# Hornsea Project Four

## Clarification Note on Drill Arisings and Deposited Sediments

**Document Reference: G5.5**

## Figure 1

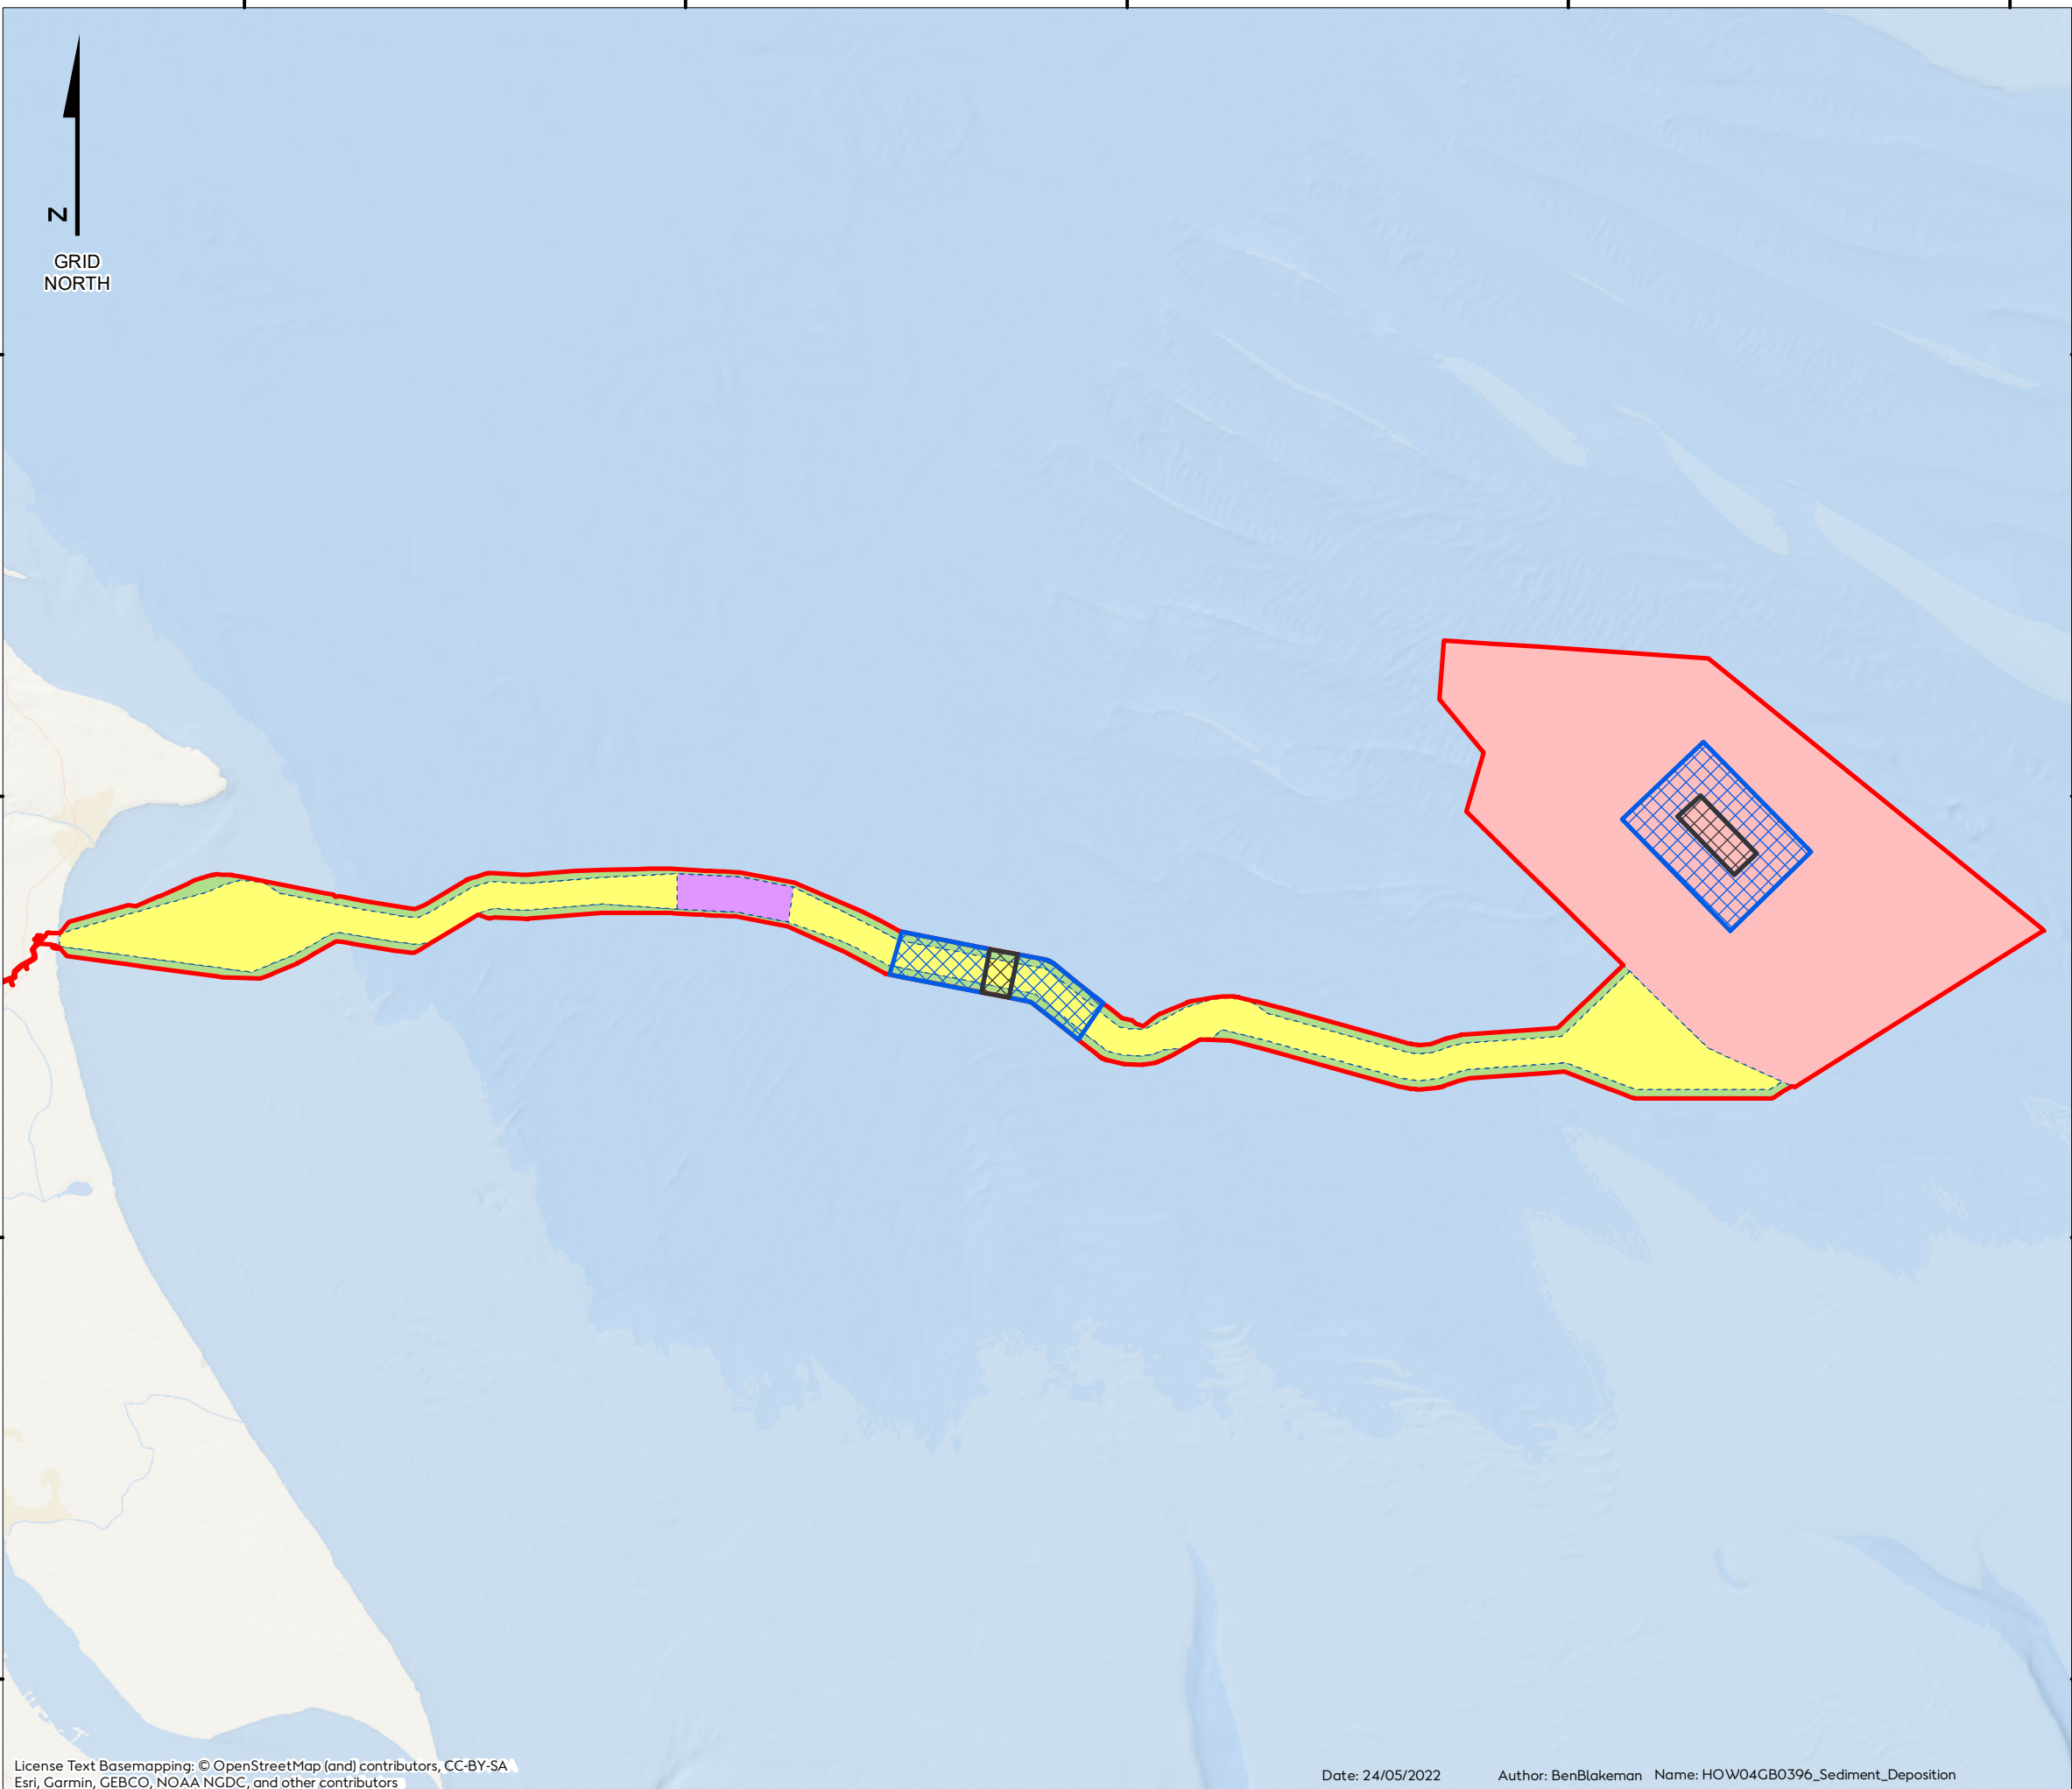
Natural England	<p>The Applicant has suggested that an assessment is provided in Section 7.1.3 of Volume A4.4.4 (APP-042) however this refers to effects of sediment plumes with no references to impacts once sediment settles. Natural England would like to see extent figures estimating the area affected by the settlement of sediment plumes</p>	<p>The Applicant can confirm that further consideration is being given to the impact of drill arisings and settled sediment plumes with a clarification note due to be submitted into Examination at Deadline 5.</p>	<p><b>Section 3</b> of this clarification note provides supporting information on MDS for the area that will be affected by disposal of material across the site during construction activities including seabed preparation, drilling and cabling and additional assessment information.</p>
Natural England	<p>Natural England note the applicants comment that any area impacted by drill arising will be within the footprint of seabed preparation works, however the impacts from drill arisings are likely to be different to those arising from the use of GBS.</p> <p>Therefore, it is still Natural England's position that impacts associated will drill arisings should be assessed in the context of Fish and Shellfish as well as other receptors within the ES.</p>	<p>The Applicant can confirm that further consideration is being given to the impact of drill arisings with a clarification note due to be submitted into Examination at Deadline 5.</p>	<p><b>Section 2</b> of this clarification note provides further information and assessment on the impact of drill arising material on benthic ecology resources.</p>

- 3.1.1.5 In terms of bed-level changes associated with dredging for all disposal activities, if the total volume of dredged material were deposited within the disposal site (array or offshore ECC), the increase in bed level height for light smothering (<5 cm as defined by the Marlin MarESA assessment), would result in a total maximum footprint of 26 km<sup>2</sup> in the export cable and 48 km<sup>2</sup> in the array area. This equates to approximately 10% of the total seabed area within the Hornsea Four array area and 9% within the Hornsea Four ECC / temporary works area.

- 3.1.1.6 With regards to heavy smothering (5-30 cm as defined by the Marlin MarESA assessment), if the total volume of dredged material were deposited it would result in a total maximum footprint of 4 km<sup>2</sup> in the export cable and 8 km<sup>2</sup> in the array area. This equates to approximately 1% of the total seabed area within the Hornsea Four array area and 2% within the Hornsea Four ECC / temporary works area.

- 3.1.1.7 **Figure 1** provides a spatial representation of the total area of deposition for both light and heavy smothering, whilst the exact area of impact cannot be defined, it provides a useful schematic of the scale of impact.
